ADDENDUM

ADDENDUM NO.: 03
PROJECT NAME: CDOT – Lincoln Square Brown Line Area Improvements
PROJECT NO.: 22705
CONTRACT NO.: C1612
DATE OF ISSUE: August 15, 2024

NOTICE OF CHANGES, MODIFICATIONS, OR CLARIFICATIONS TO CONTRACT DOCUMENTS

SCALE: 1"=20' SHEET OF SHEETS		REMOVAL PLAN LELAND AVENUE	DRAWING NO. REM-2 SHEET NO. 45
----------------------------------	--	-------------------------------	--

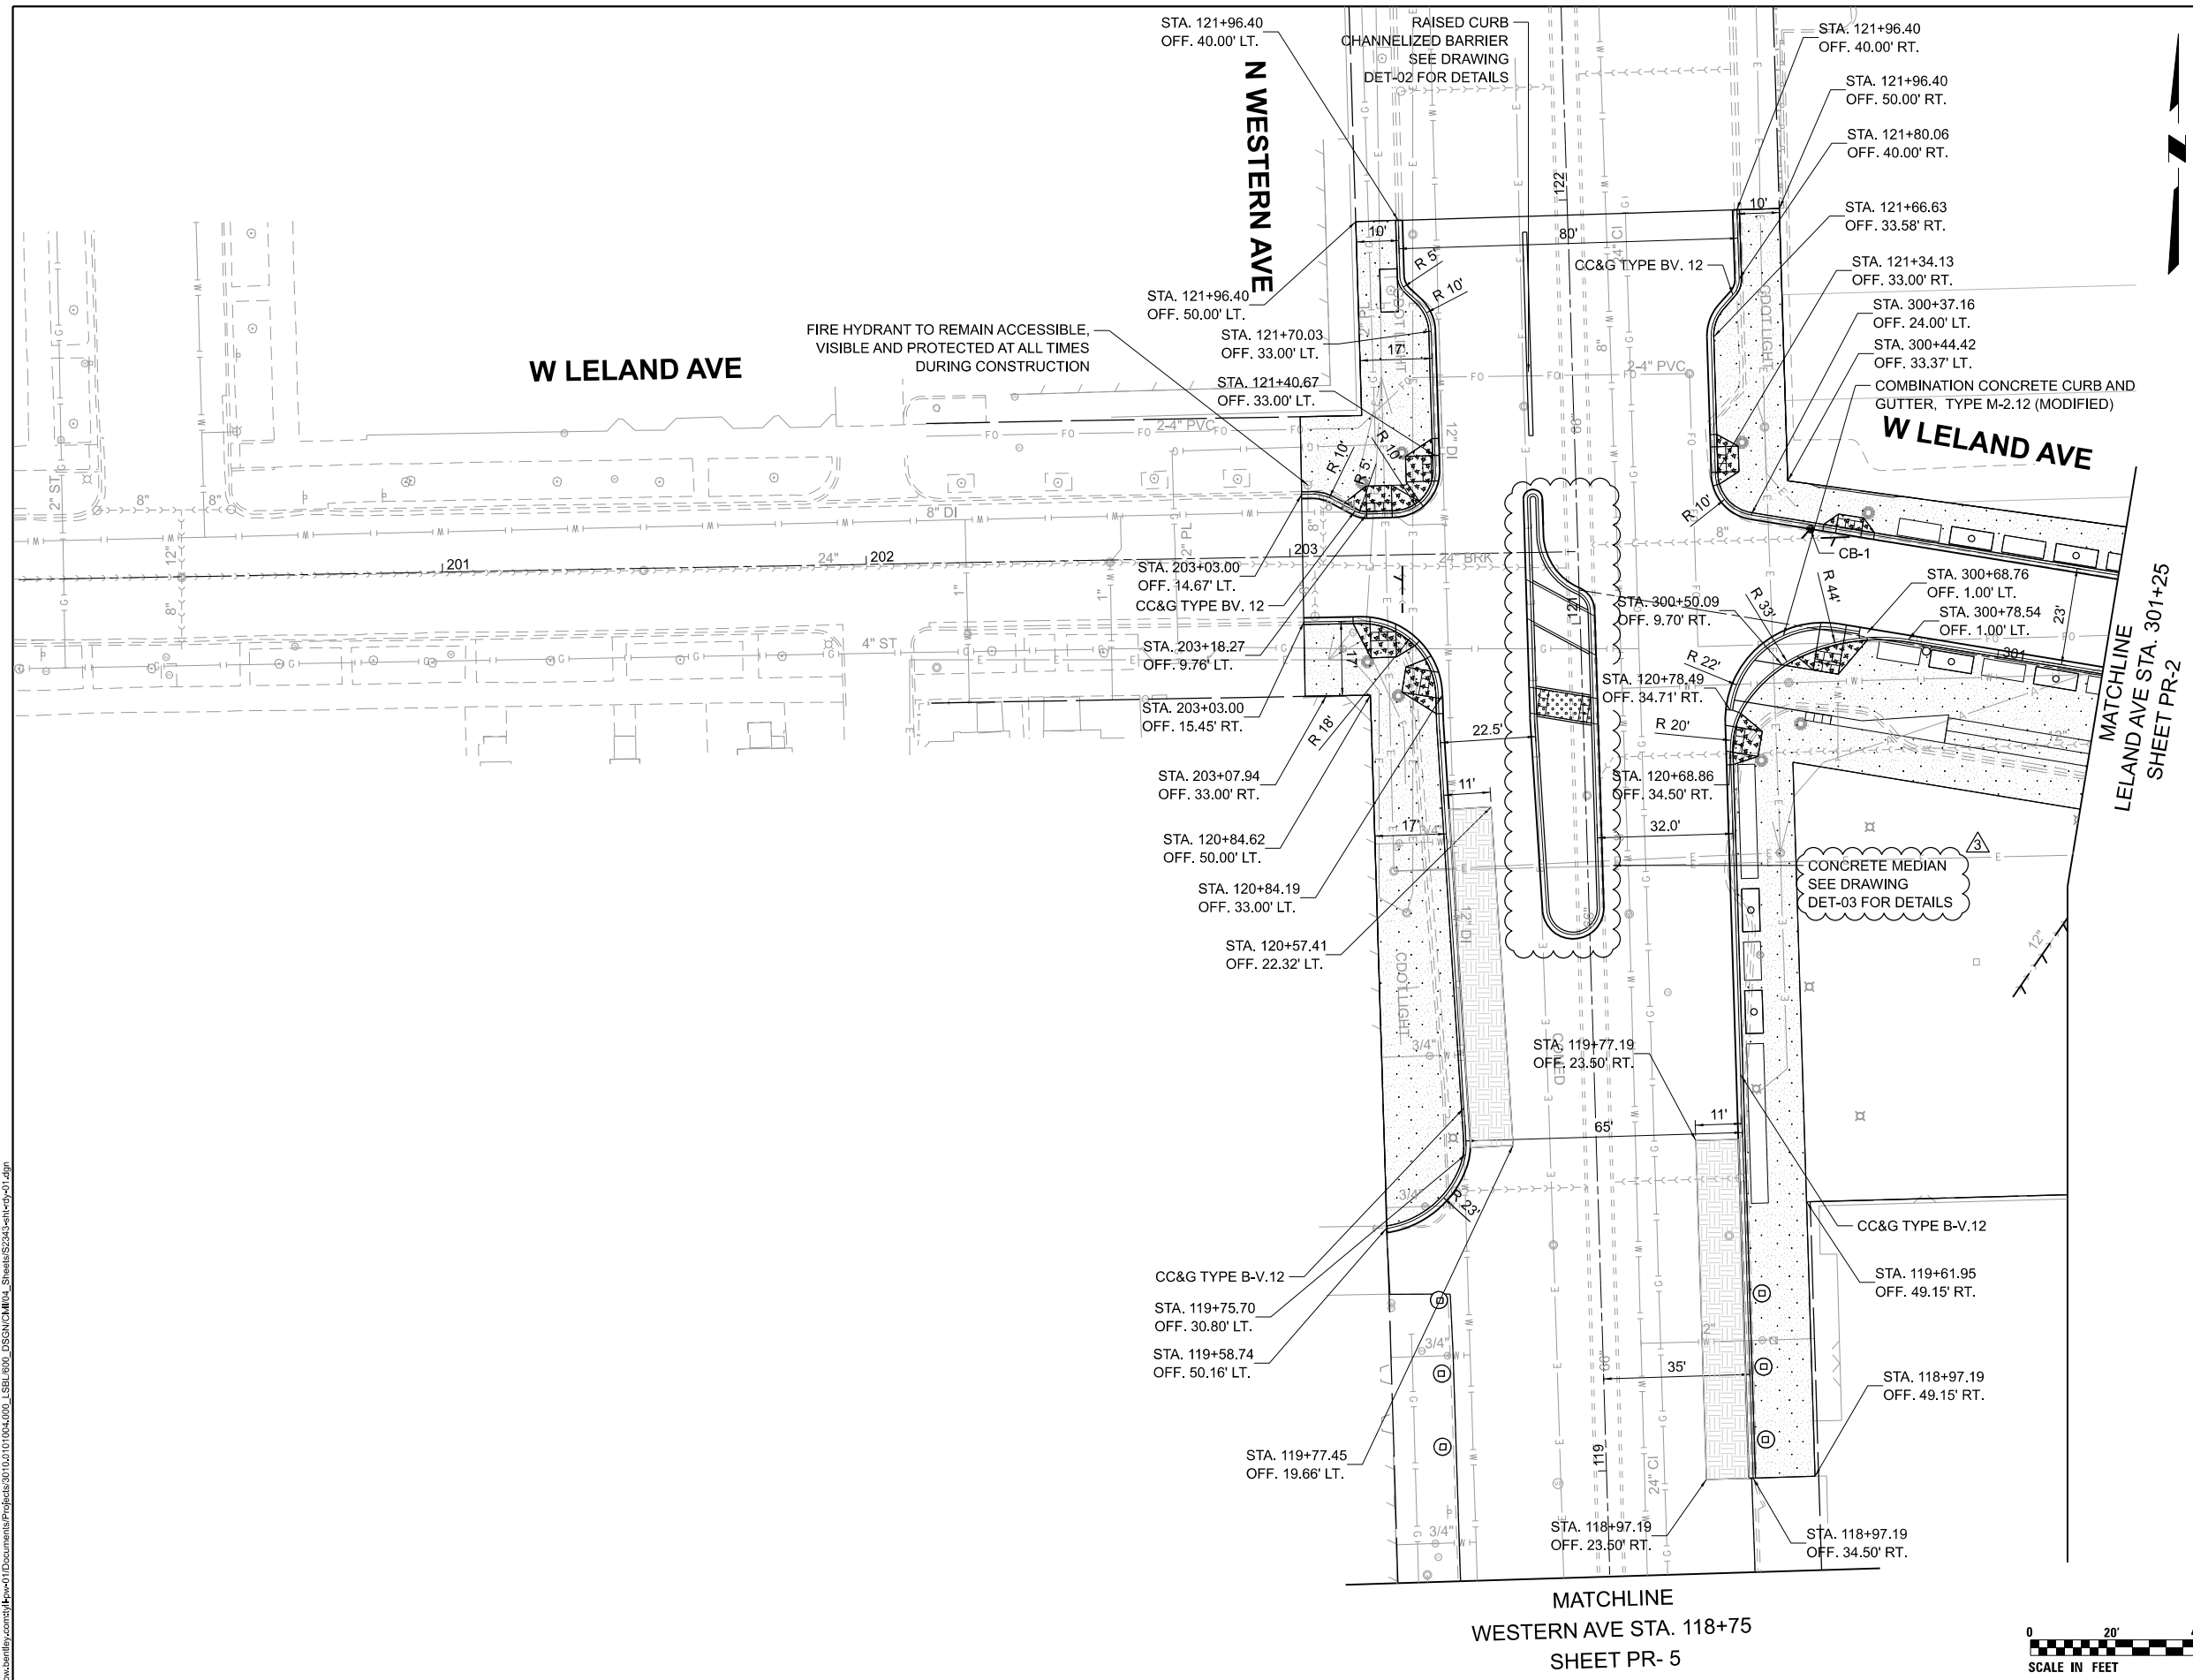
Question: Referencing Sheet 45 REM-2, the south side of Parcel area A and B shows Asphalt removal variable depth but Sheet 50 PR-2 shows 8" PCC pavement. Which is correct?

Question: Reference Sheet 44, 45, 49 and 50, the quantities for Hot mix asphalt depth removal variable depth and new asphalt is not accurate to the quantities given. Please correct quantities.

Response: The area under the CTA tracks is to be resurfaced as shown on Drawing REM-2. Drawing PR-2 has been revised and is included in this addendum.

Response: Drawings SOQ-1, REM-1, REM-2, PR-1 and PR-2 for areas related to HMA surface removal, pavement removal and HMA resurfacing have been revised and are included in this addendum.

PROPOSED IMPROVEMENT PLAN		DRAWING NO.
LELAND AVENUE		PR-1
SCALE: 1"=20'	SHEET OF SHEETS	SHEET NO.
		49

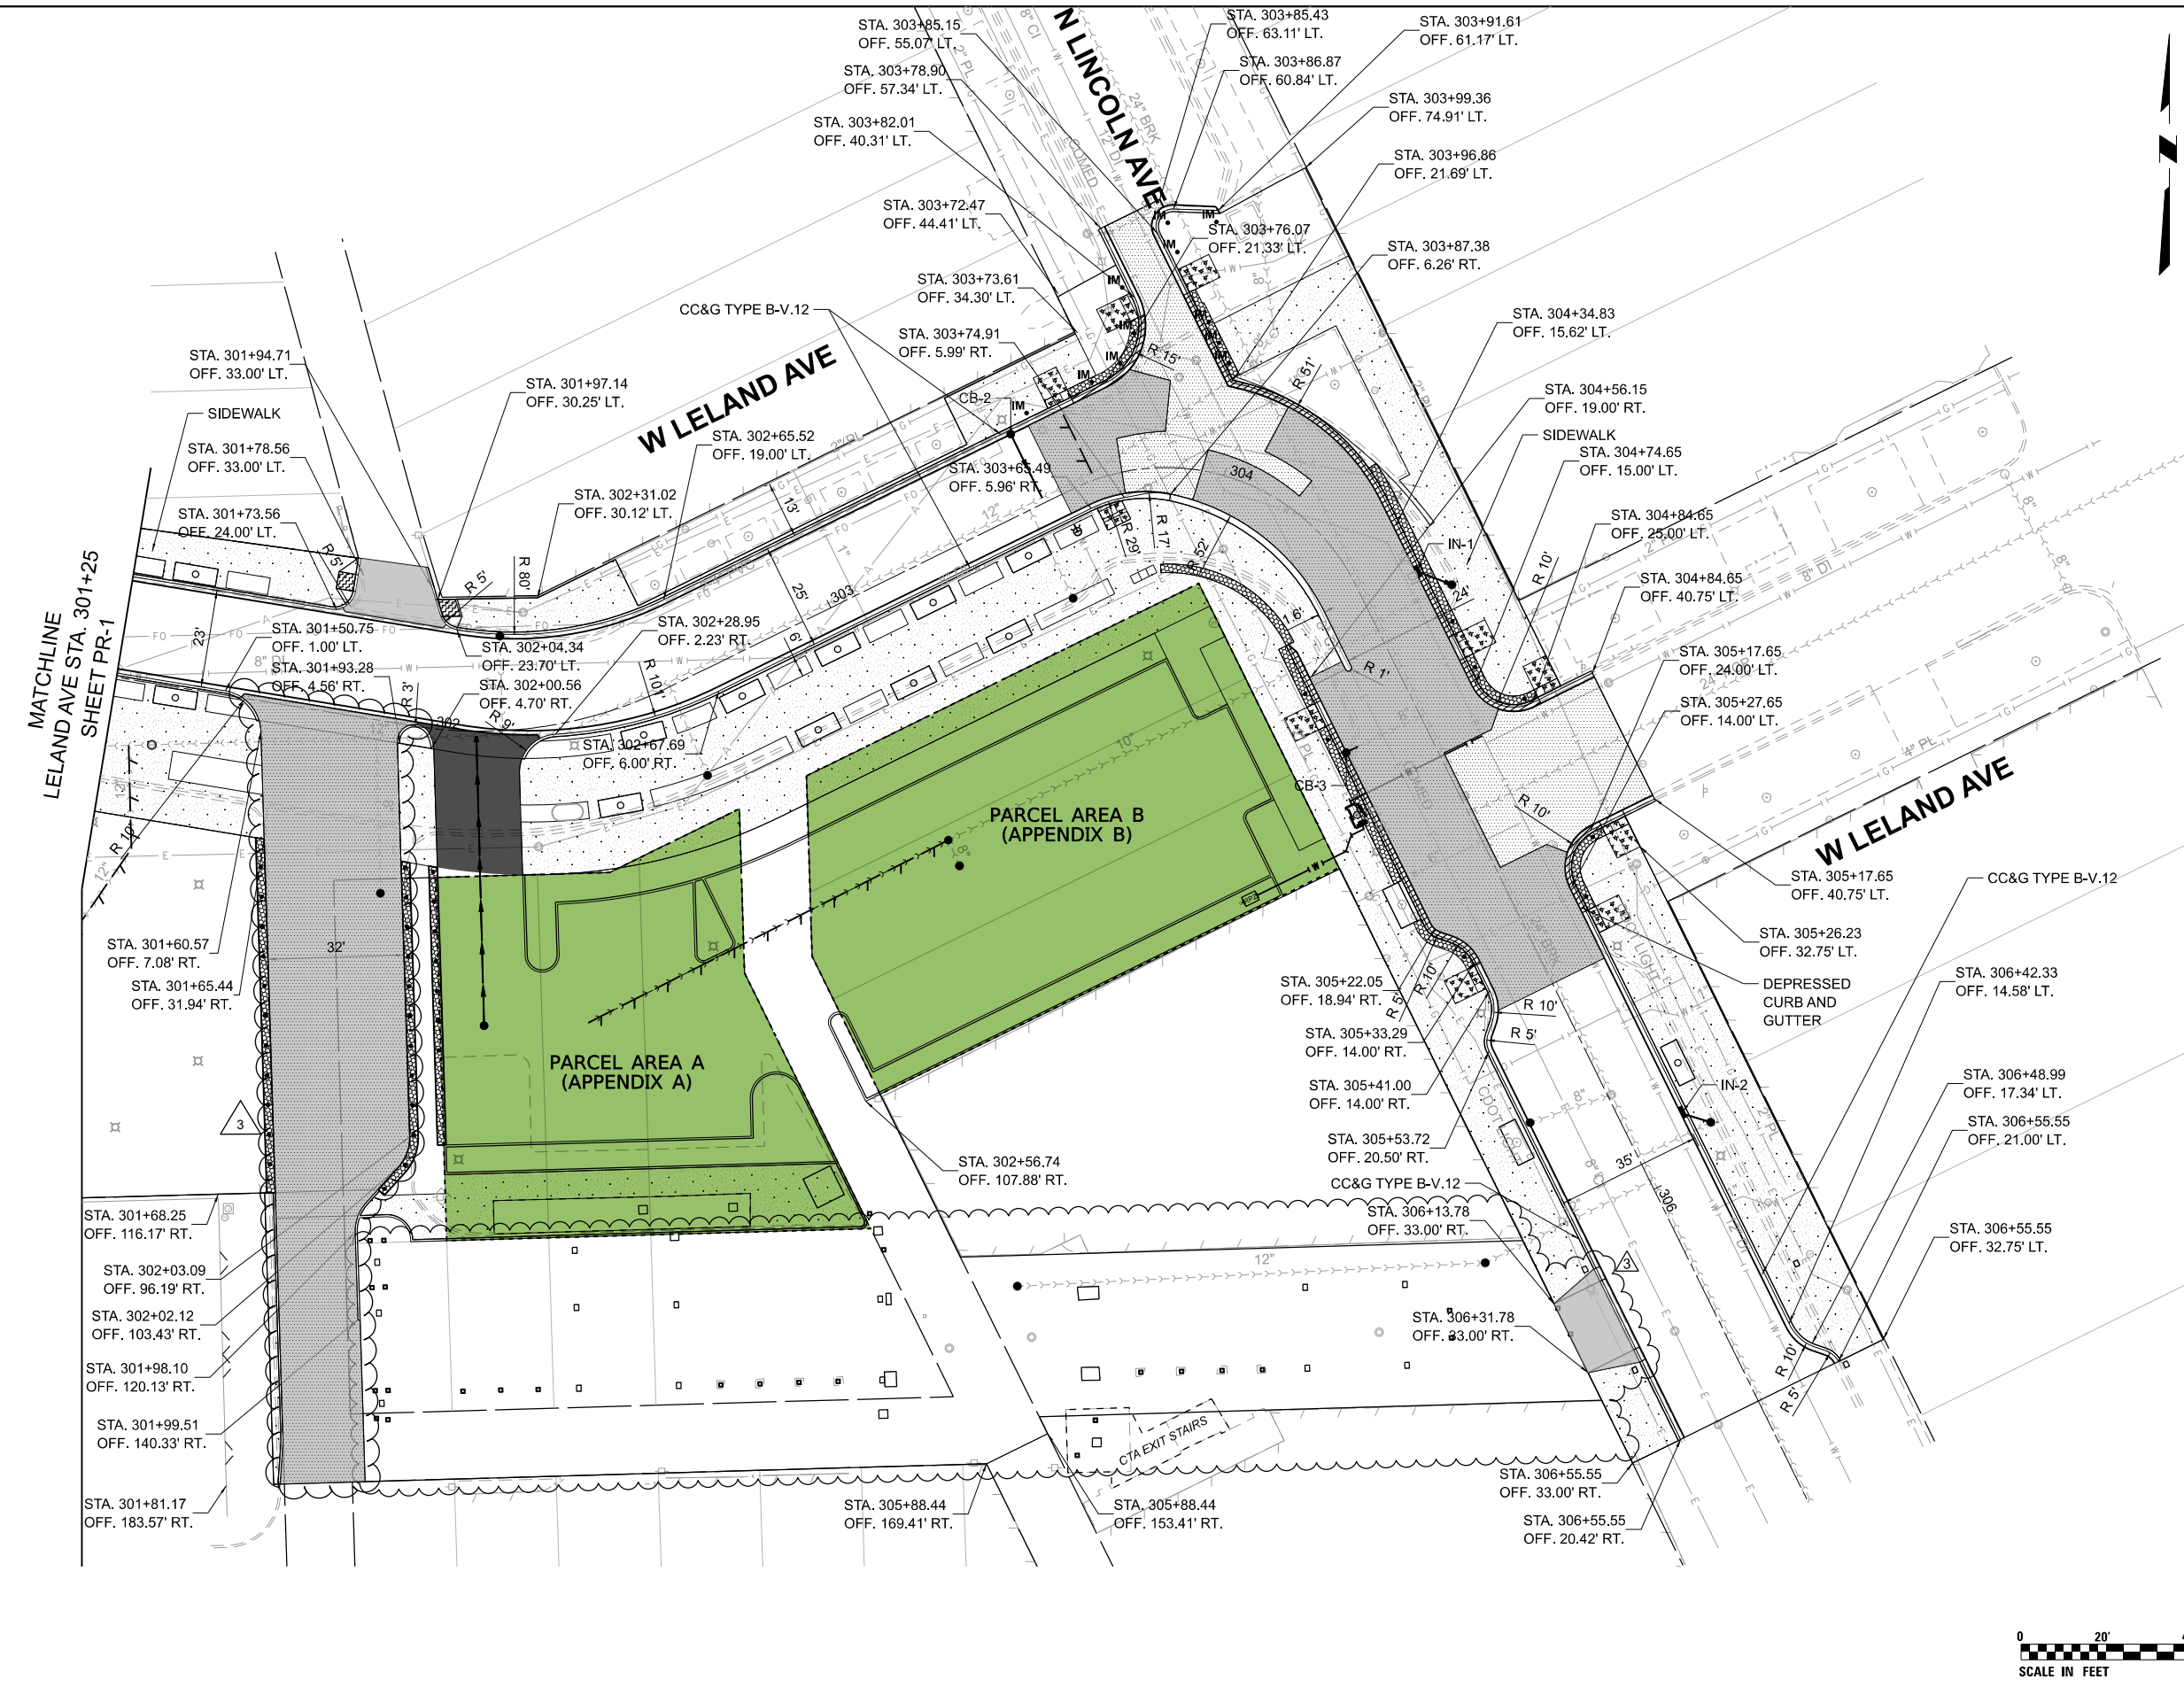
Question: Referencing Sheet 17 TYP-3, the legend shows Hot-Mix Asphalt Binder Course, IL-19.0, N70, 2-1/4" but there is only a Binder Course IL-9.5, N70 Bid item. Please clarify which mix is correct.

Response: The mix type is Hot-Mix Asphalt Binder Course, IL-9.5, N70. Pay Item Code has been revised to '40602985'. Both the Schedule of Prices and Drawings SOQ-1, TYP-3, TYP-4, PR-1 and PR-2 have been revised and are included in this addendum.
